**BEFORE THE  
LOUISIANA PUBLIC SERVICE COMMISSION**

**Docket No. I-36181**

**SIERRA CLUB'S COMMENTS ON ENTERGY LOUISIANA'S  
NOVEMBER 22, 2021 DATA FILING FOR THE  
INTEGRATED RESOURCE PLAN CYCLE**

March 15, 2022

**Figure 2: On-Shore Wind Capital Costs (\$/kW, nominal)<sup>7</sup>**

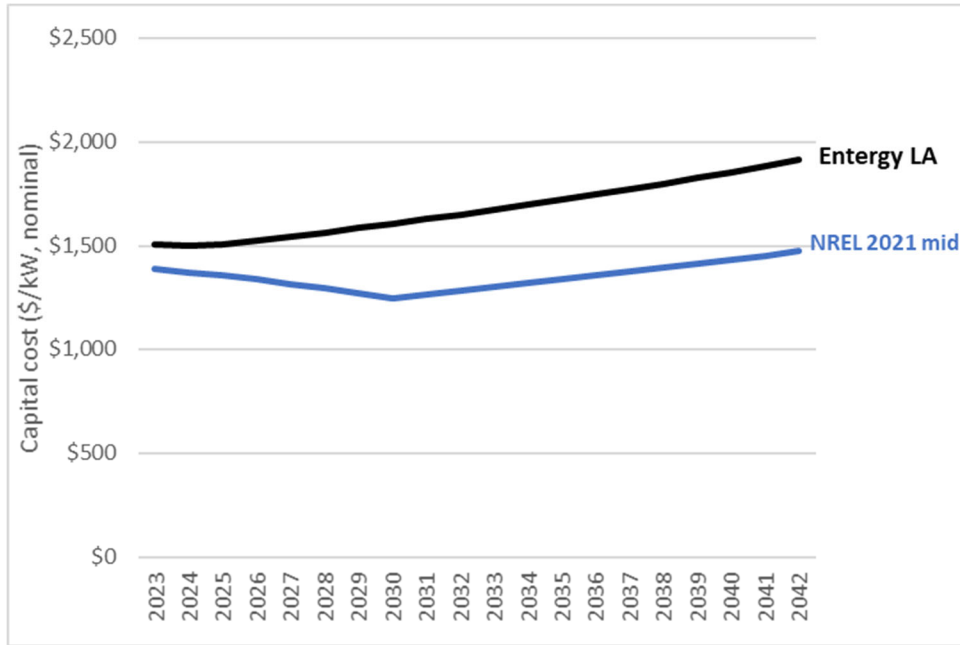
When modeling off-shore wind, the Company relies on recent forecasts from the NREL 2021 ATB (National Renewable Energy Laboratory's Annual Technology Baseline), which is a reasonable source. For on-shore wind, however, the Company relies on mostly outdated information including one forecast from 2019 and several from 2020 (such as the year-old NREL 2020 ATB).<sup>6</sup> A comparison of the NREL 2021 ATB costs to Entergy's assumed on-shore wind capital costs is shown below in Figure 2.

The Company’s use of outdated on-shore wind forecasts is leading it to overstate the costs of this resource. We recommend that Entergy use the NREL 2021 ATB, which is consistent with its modeling of off-shore wind costs. In addition, the Company’s assumed capacity factor for on-shore is based solely on data from MISO South;<sup>8</sup> but if Entergy could access higher quality wind elsewhere then it should also model such options, for instance, a PPA for wind in Southwest Power Pool.
